## Question

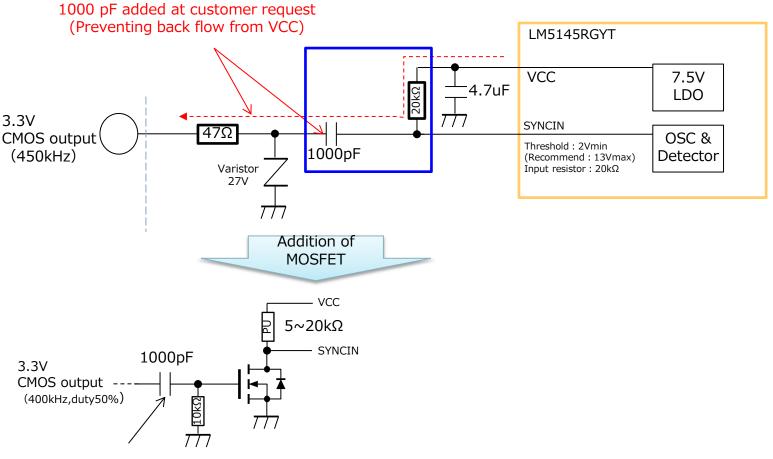
Is it possible to perform FPWM and frequency SYNC operation with the addition of MOSFET shown below? Is there no problem?

Is there a specification of the input capacitance of the SYNC pin when adding a MOSFET? When 5 k $\Omega$  PU, the load of VCC increases by about 1.5 mA, but is there a problem within 20 mA in total with SW operation?

Add by fail safe
Prevents transition from FPWM to DCM operation of the LM 5145 when the signal becomes continuous Hi.
(This power supply is required for current sink operation)
